RECORD DRAWINGS

# Kingston Public Library

Title  
Site Plan

No. A-0

Title  
**PLUMBING PLAN**  
Date FEB. 9, 1994  
Scale 1/8" = 1'-0"

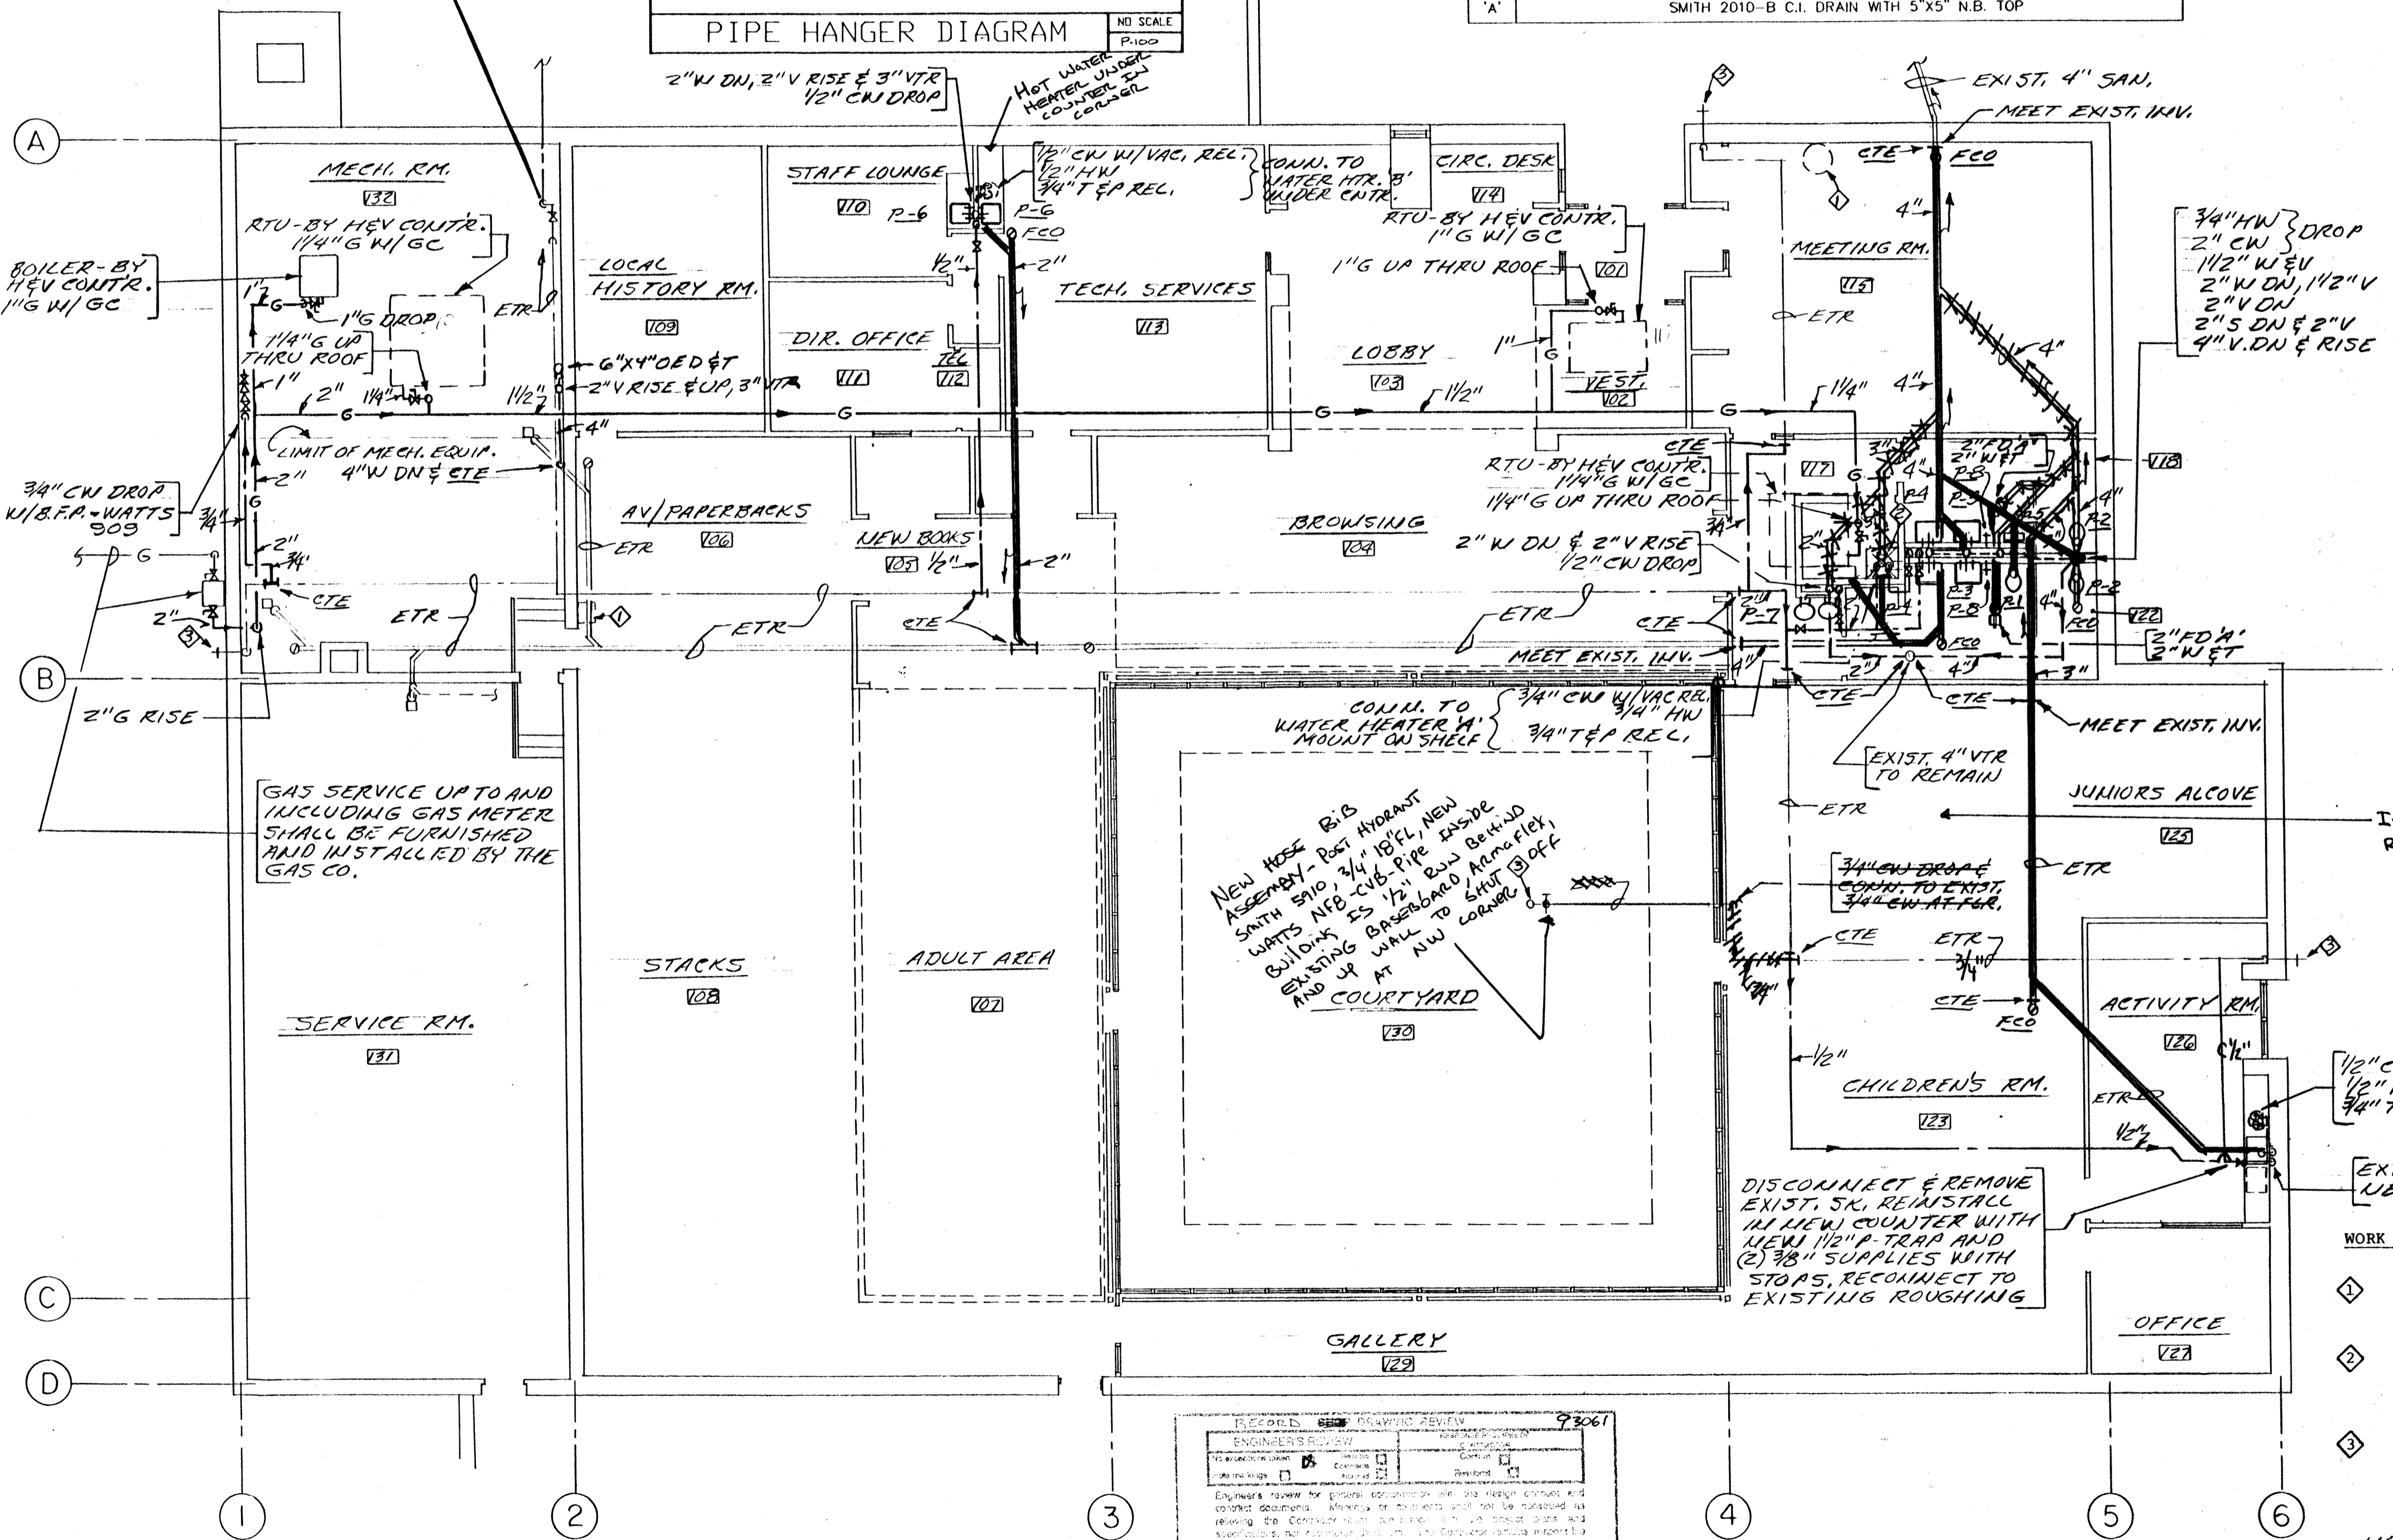
Replace existing 2 1/2" GATE VALVE w/ NEW 2 1/2" BALL VALVE.
